HARTZELL PROPELLER INC.
SERVICE LETTER
TRANSMITTAL SHEET
HC-SL-61-241
Propeller - New Blade Seal

February 2, 2015

This page transmits a revision to Service Letter HC-SL-61-241.

Revision 3 is issued to change the following in the Service Letter:

O-ring and Blade Seal Installation
Figure 1

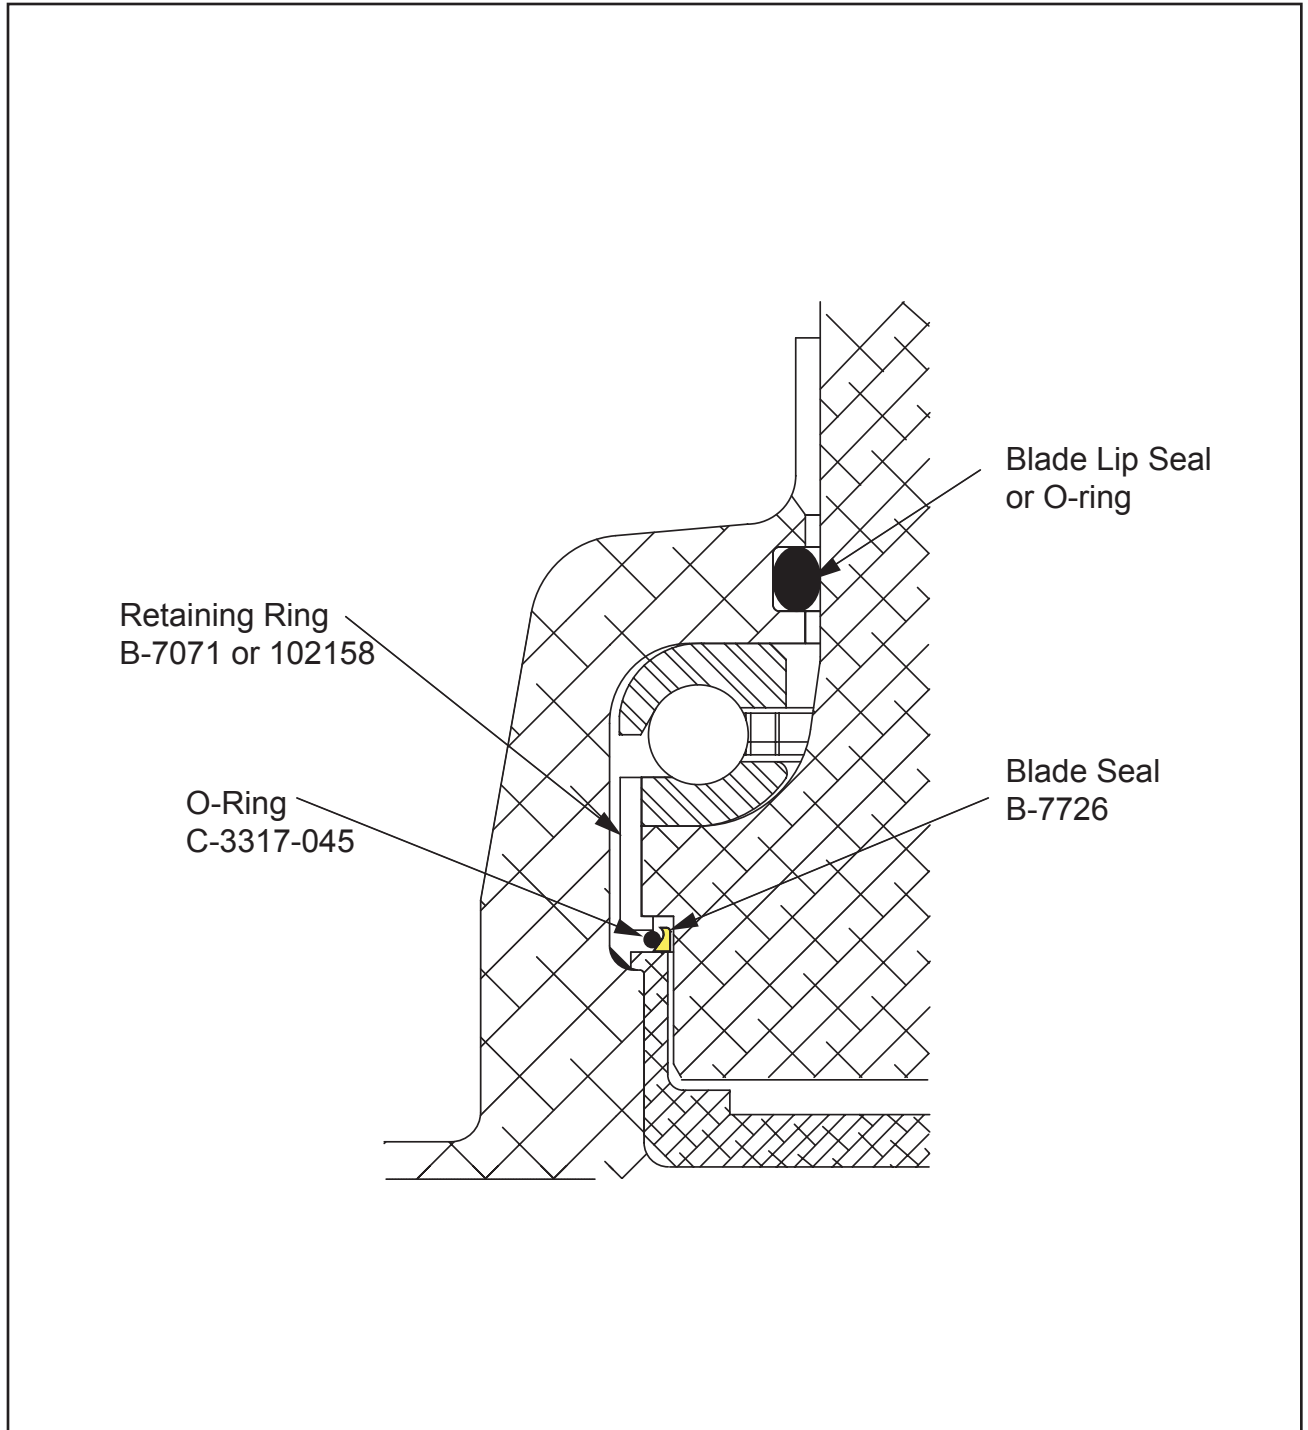
- (1) The current propeller designs have a slip fit between the preload plate and the blade butt.
 - (a) If not properly serviced, this small gap may permit grease to enter the central hub cavity during the periodic lubrication of the blade retention area.
 - (b) Migration of the grease from the blade retention area to the hub central cavity can potentially cause grease leaks or vibration.
- (2) Hartzell Propeller Inc. has designed an internal blade butt seal that restricts migration of grease into the hub cavity. See Figure 1.

O-ring Installation on Blade Seal
Figure 2

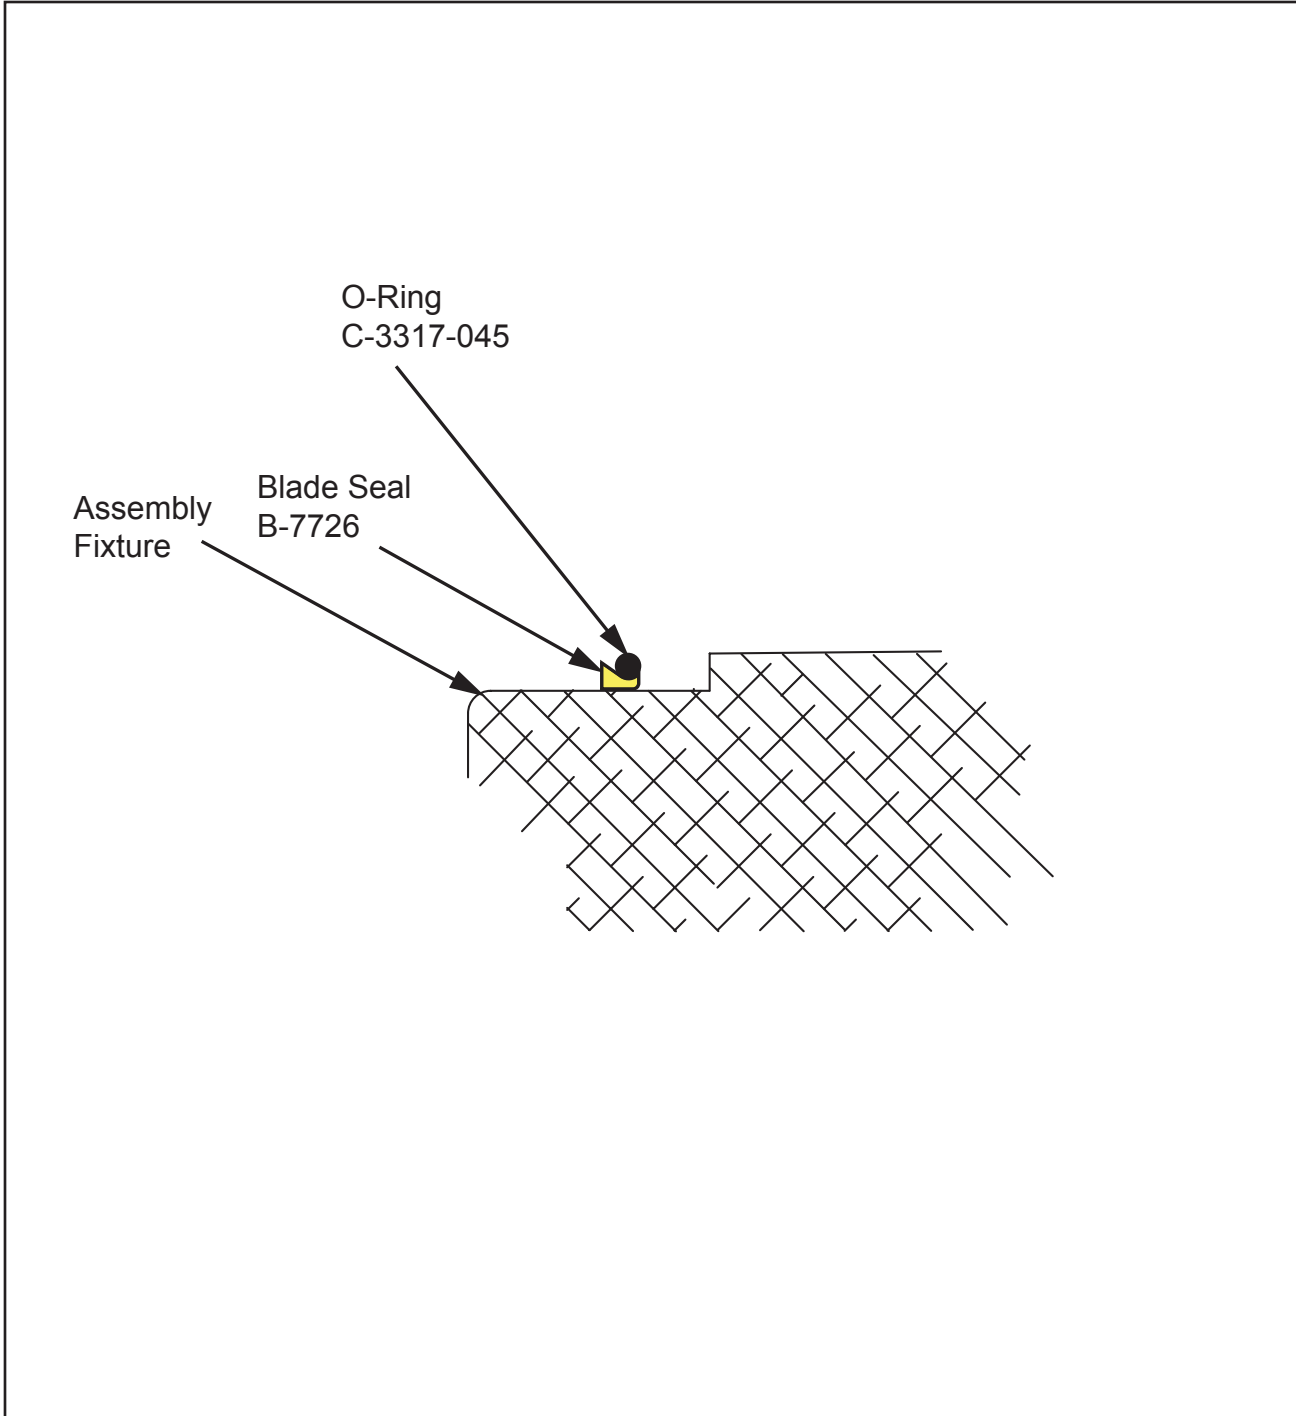
- (d) Install the C-3317-045 O-ring into the recessed area of the B-7726 blade seal as shown in Figure 2. If the O-ring does not remain in place, replace the blade seal.

- (3) Remove the blade seal assembly as shown in Figure 2 from the assembly fixture and install the assembly on the blade, as shown in Figure 3.
- (4) The blade seal with the O-ring installed must be installed into the home position without being forced as shown in Figure 3. If the blade seal appears to be significantly out-of-round then perform the following check:
 - (a) The home position is encircling the blade butt OD while resting against the bearing retaining ring with the lip of the blade seal sliding between blade OD and ID of the bearing retaining ring as shown in Figure 3.
 - (b) If the blade seal with O-ring installed fails to retain the home position, replace the blade seal.
- (5) Install the preload plate in accordance with the applicable propeller overhaul manual.

**Blade Retaining Ring Inspection
Figure 4**

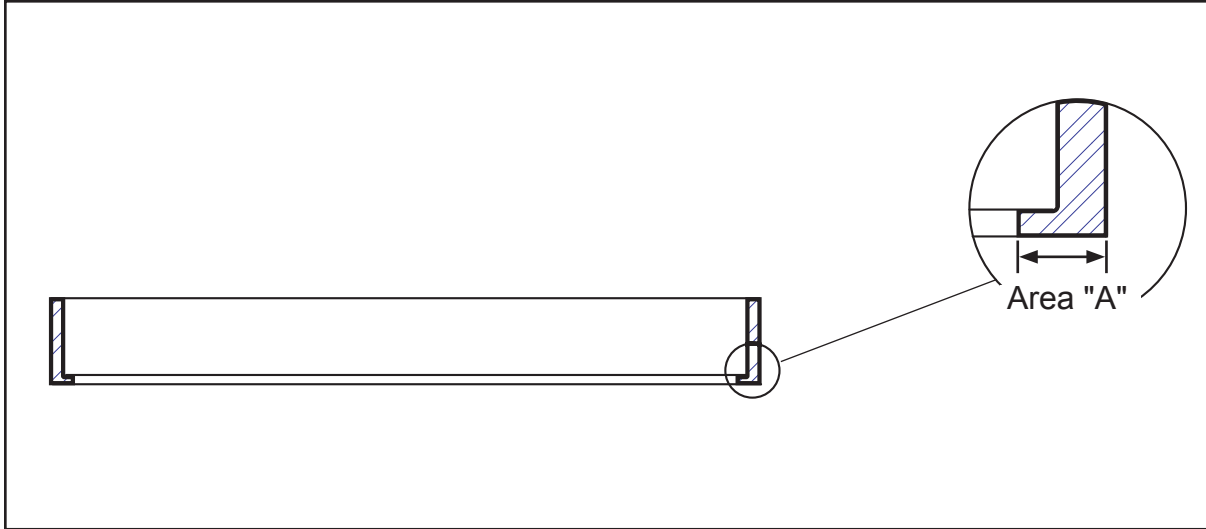
- (a) Installation of the B-7726 blade seal and the C-3317-045 O-ring is optional.
 - (b) When the B-7071 bearing retaining ring is used without the blade seal and O-ring, propeller assemblies may contain both the B-7071 and B-1041 bearing retaining rings.
- (4) Inventory of the B-1041 bearing retaining ring may be used until depleted.
 - (5) For identification purposes only, the dimension of Area "A" on the B-7071 is 0.153 inch (3.88 mm). The dimension of Area "A" on the B-1041 is 0.180 inch (4.57 mm). Refer to Figure 4.
 - (6) For identification purposes only, the dimension of Area "A" on the 102158 is 0.153 inch (3.88 mm). The dimension of Area "A" on the A-2204 is 0.180 inch (4.57 mm). Refer to Figure 4.

<u>Inspect</u>	<u>Serviceable Limits</u>	<u>Corrective Action</u>
(a) Except for Area "A", visually examine the bearing retaining ring for corrosion and pitting. Refer to Figure 4.	Corrosion is not permitted. The maximum permitted depth of pitting is 0.005 inch (0.12 mm). Pitting must not interfere with the ability of the bearing retaining ring to fit tightly to the blade and the bearing race.	If there is corrosion, remove the corrosion using glass bead cleaning. Refer to the Cleaning chapter of Hartzell Propeller Inc. Standard Practices Manual 202A (61-01-02). If the corrosion or pitting is greater than the permitted serviceable limits, replace the bearing retaining ring.

(b) Visually examine the bearing retaining ring for corrosion, pitting, or wear in Area "A". Refer to Figure 4.	Corrosion, pitting, damage, or wear is not permitted.	If there is corrosion, pitting, or wear, replace the bearing retaining ring.

(c) Except for Area "A", visually examine the bearing retaining ring for wear, damage, or fretting. Refer to Figure 4.	The bearing retaining ring must fit tightly to the blade and the bearing race when installed over the blade and the bearing race.	If the wear, damage, or fretting is more than the permitted serviceable limits, replace the bearing retaining ring.

**B-7726 Blade Seal Width
Figure 5**

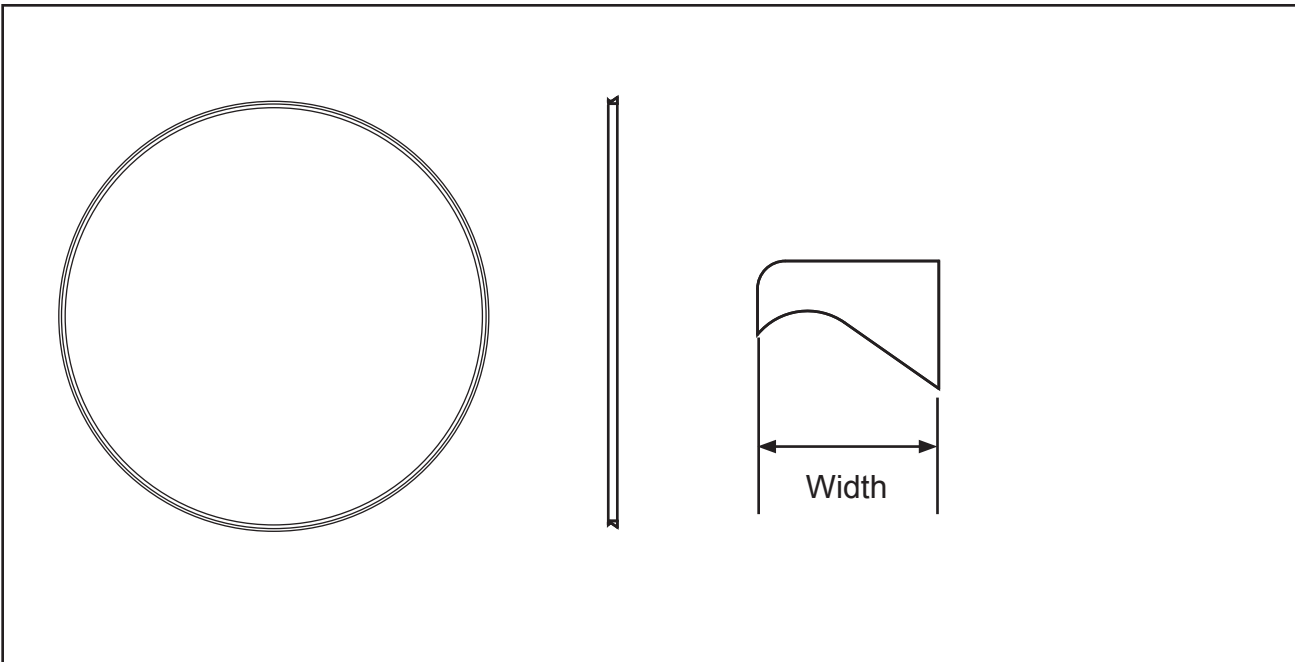
<u>Inspect</u>	<u>Serviceable Limits</u>	<u>Corrective Action</u>
(a) Using 10X magnification and an appropriate light source, visually examine the blade seal for damage, missing material, separation, or form irregularities of the continuous ring.	Damage, missing material, separation, or significant form irregularities are not permitted.	If the damage or other conditions are more than the permitted serviceable limits, replace the blade seal.
(b) Visually examine the width of the blade seal for wear. If there is wear, measure the width of the blade seal. Refer to Figure 5.	The minimum permitted width is 0.090 inches (2.29 mm).	If the width is less than the permitted serviceable limits, replace the blade seal.
